April 4, 2023

**RE: Prairie Point Site Plan No 1 (Kings Point North) Third Submission Review Response to Comments**

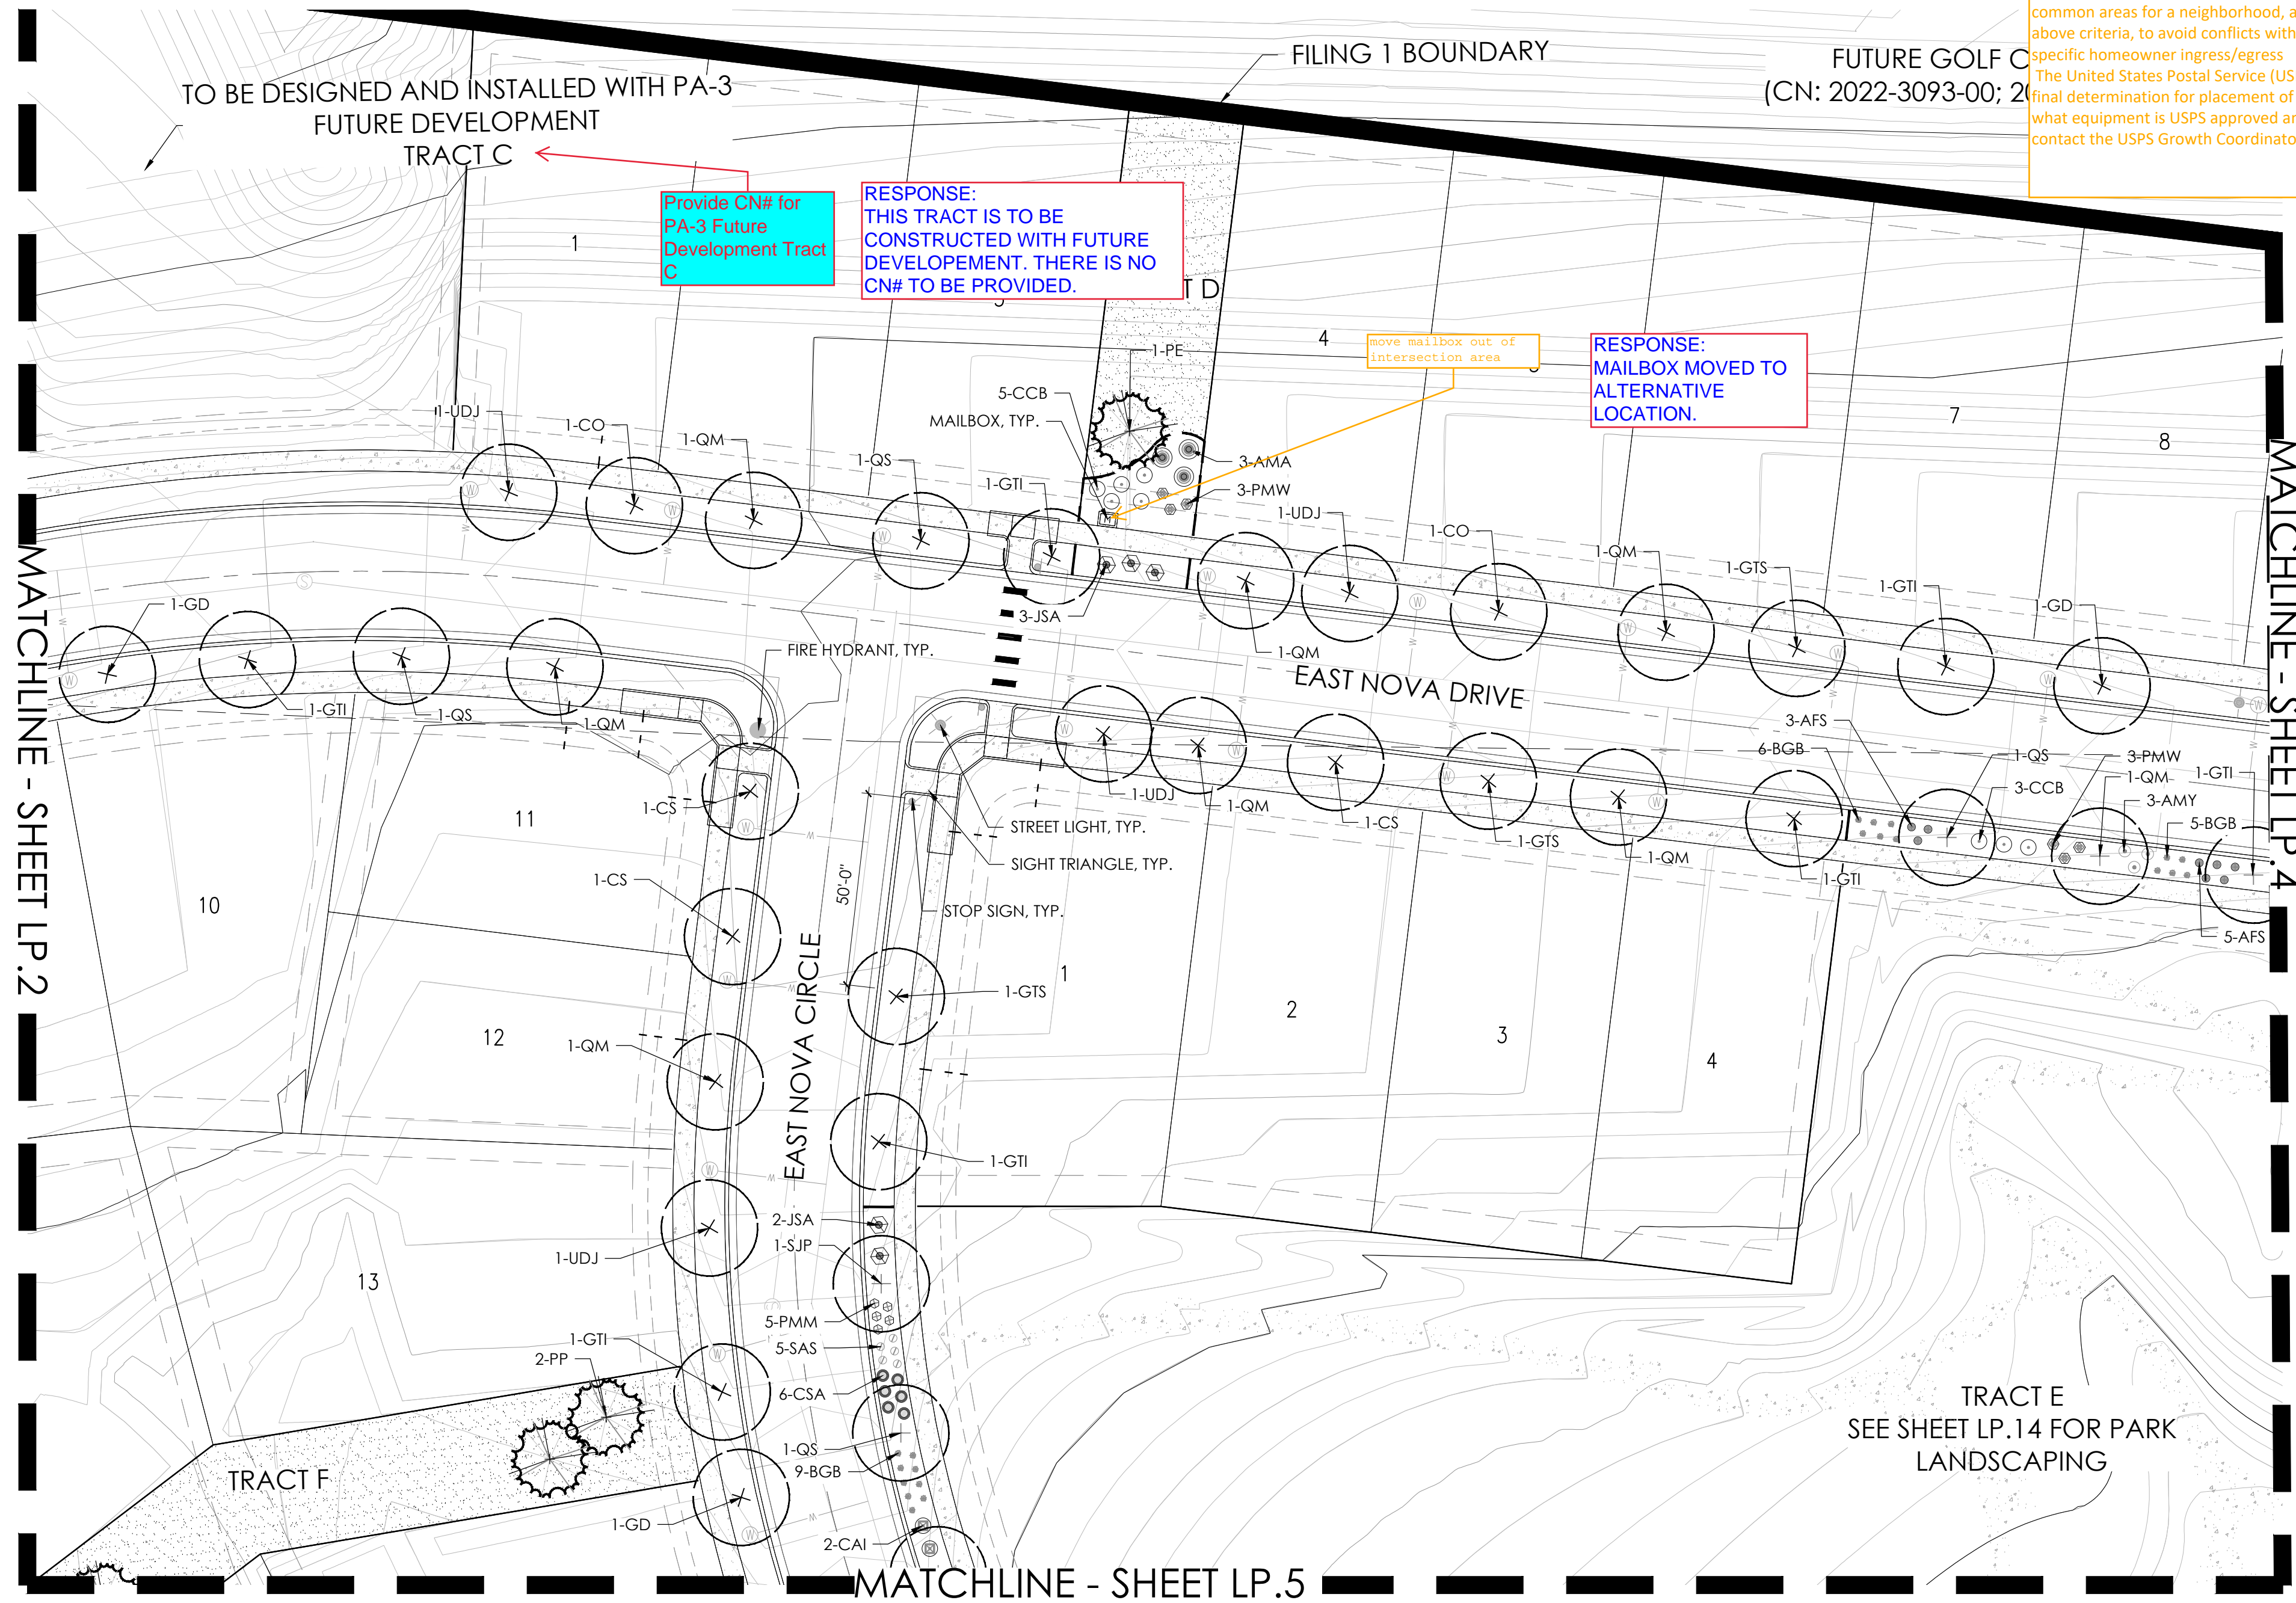
NOTE:  
ALL PROPOSED LANDSCAPING WITHIN THE SIGHT  
TRIANGLE SHALL BE IN COMPLIANCE WITH COA  
ROADWAY SPECIFICATIONS SECTION 4.04.2.10

RESPONSE:  
NOTED.

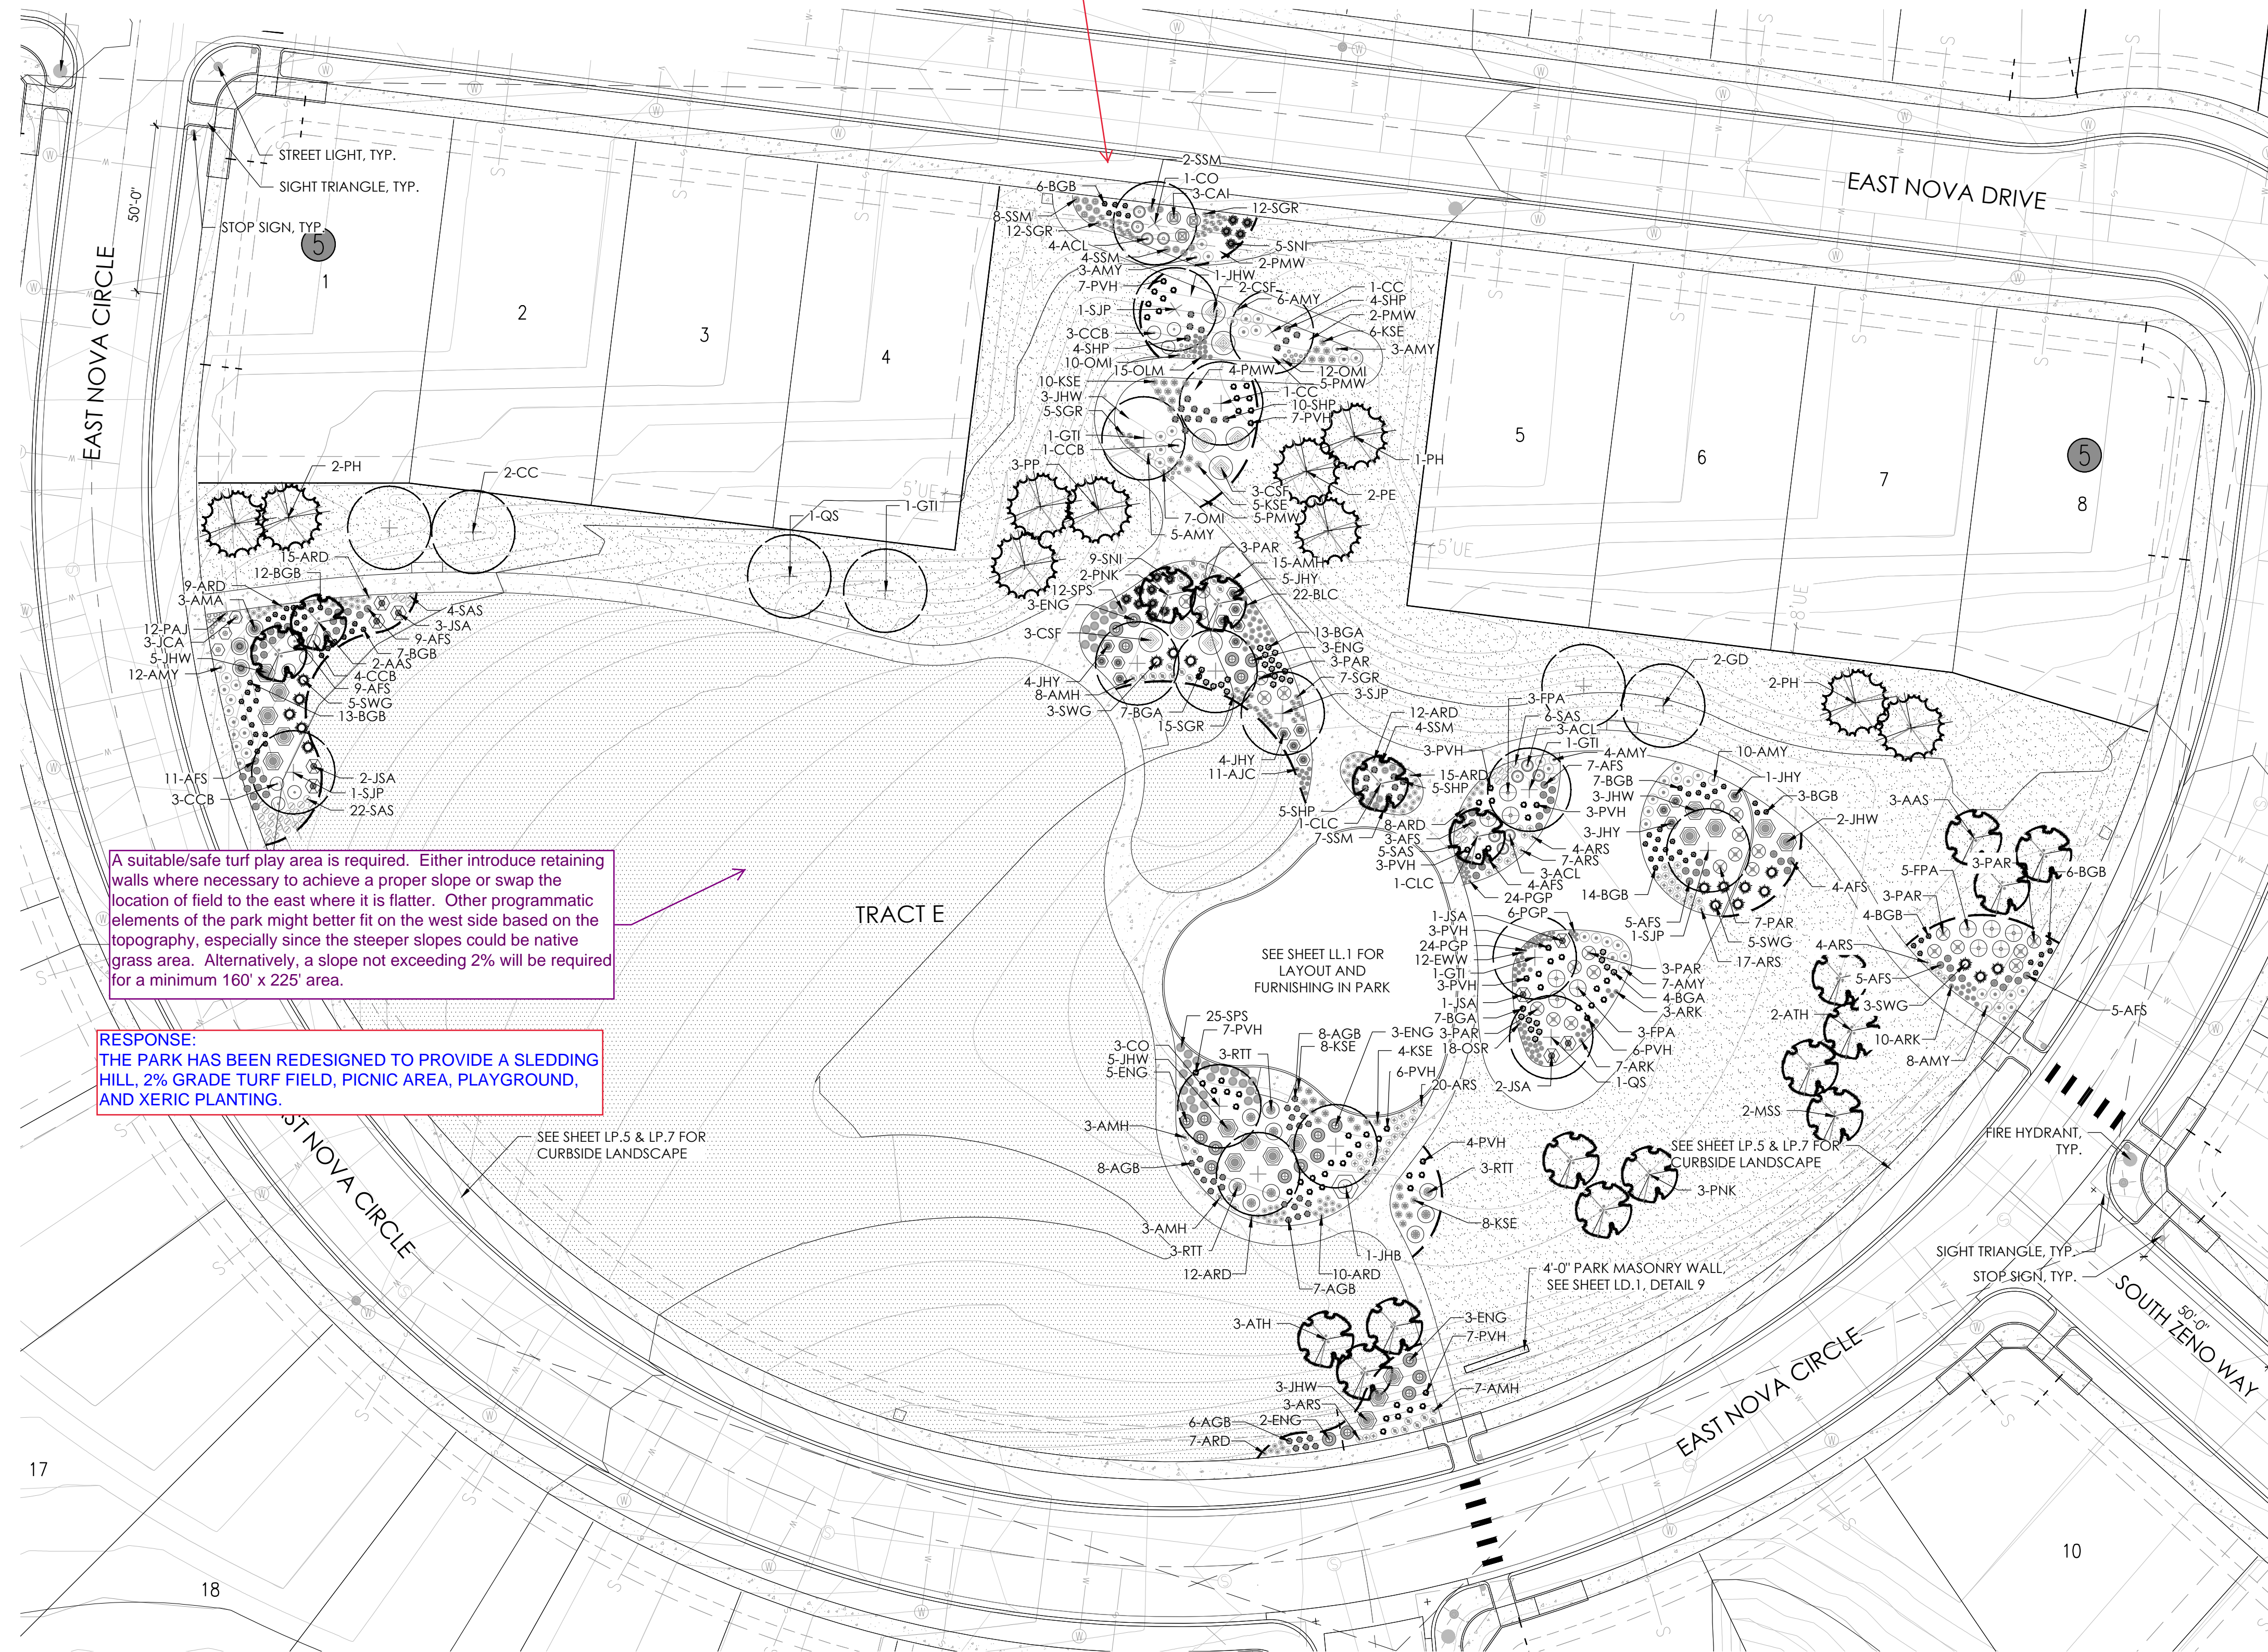
Add note: Refer to  
curbside landscaping on  
Sheet LP-3.

A suitable/safe turf play area is required. Either introduce retaining walls where necessary to achieve a proper slope or swap the location of field to the east where it is flatter. Other programmatic elements of the park might better fit on the west side based on the topography, especially since the steeper slopes could be native grass area. Alternatively, a slope not exceeding 2% will be required for a minimum 160' x 225' area.

RESPONSE:  
THE PARK HAS BEEN REDESIGNED TO PROVIDE A SLEDDING HILL, 2% GRADE TURF FIELD, PICNIC AREA, PLAYGROUND, AND XERIC PLANTING.

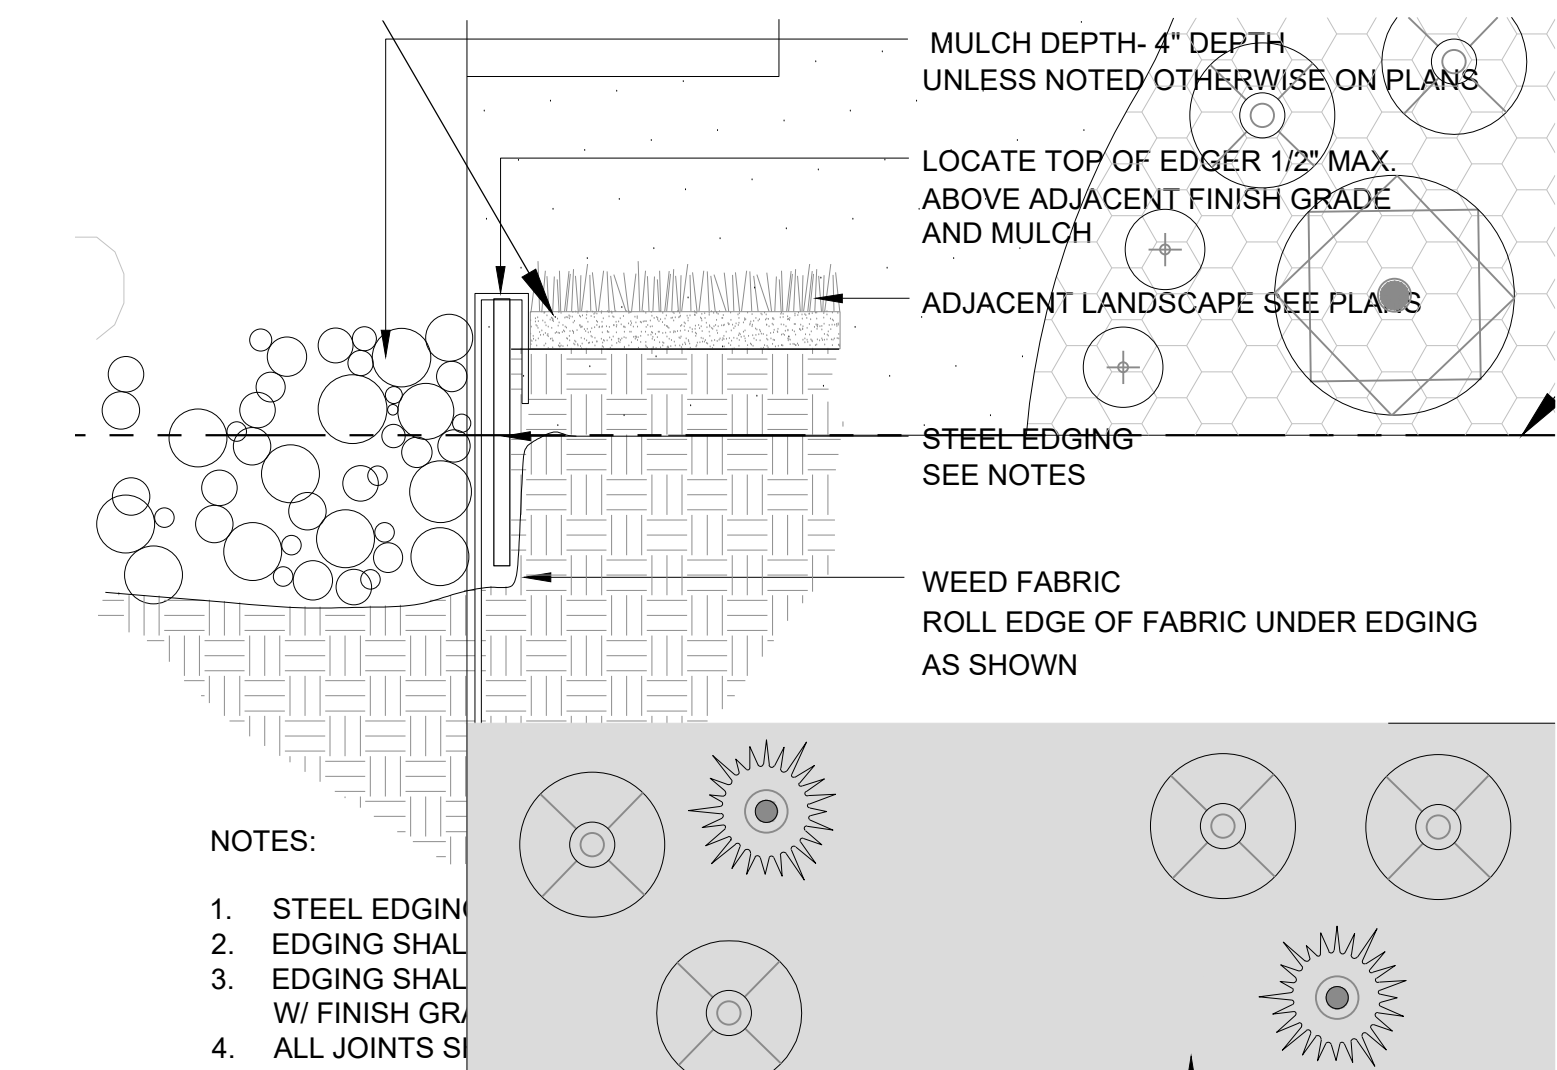
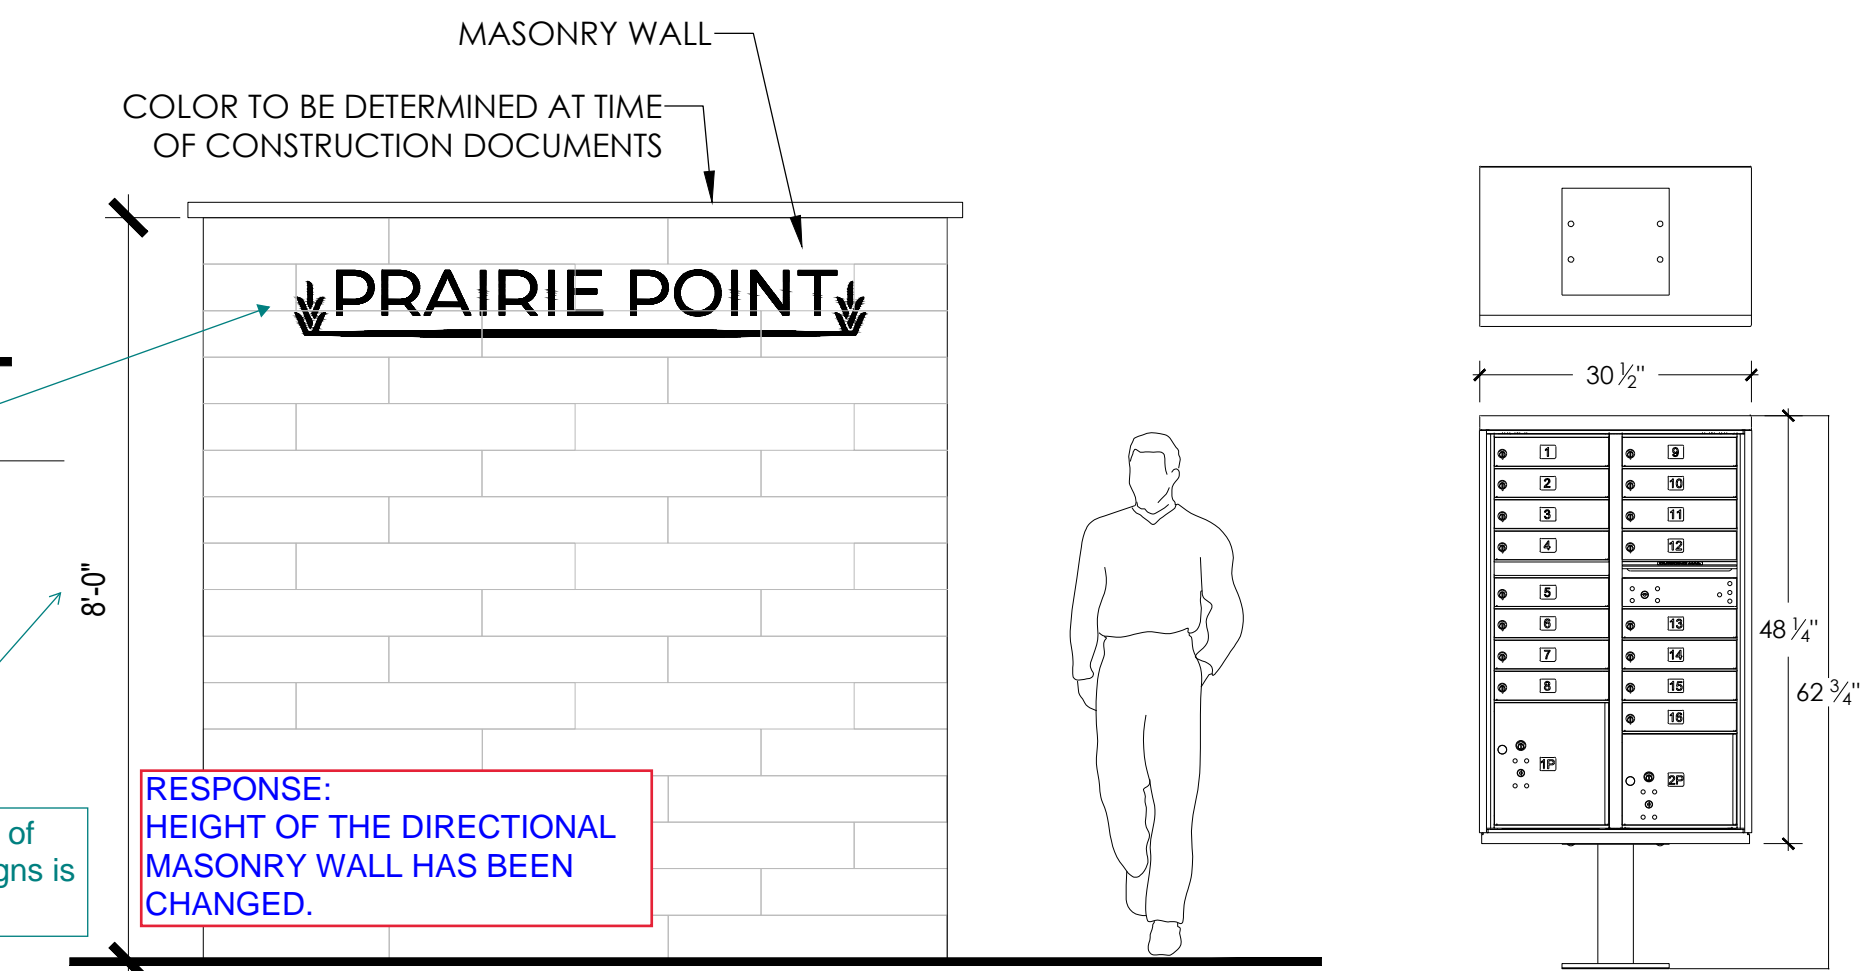
Provide specific material call-outs and colors for each detail. City staff does not have access to construction documents.

RESPONSE: MATERIAL CALL-OUT HAS BEEN PROVIDED.
